SERVICE LETTER

No. 627

Propeller Installation

PA-23-250 (Six Place) and
PA-E23-250 (Six Place) Aztec
PA-24-260 Comanche

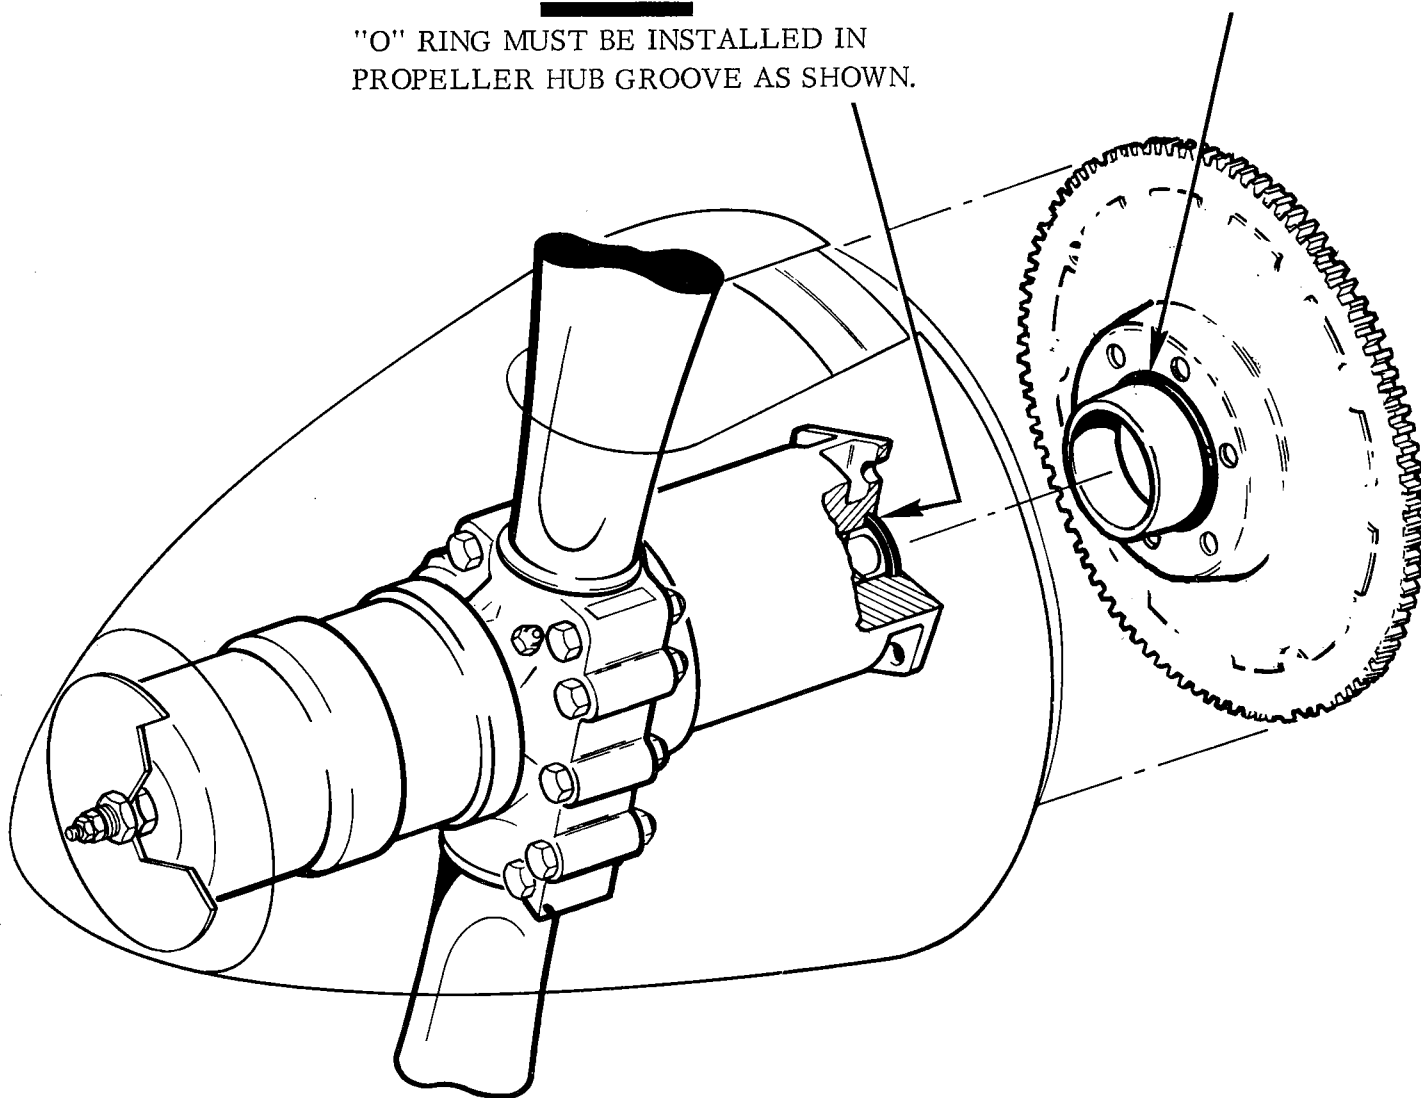
A. If an "o" ring exists in this location, the "o" ring must be discarded and the propeller should be removed from the aircraft and inspected to insure that the proper "o" ring is correctly installed in the propeller hub groove -- as shown in attached sketch.

CORRECT

"O" RING MUST BE INSTALLED IN
PROPELLER HUB GROOVE AS SHOWN.

INCORRECT

DO NOT INSTALL "O" RING
OVER CRANKSHAFT FLANGE.
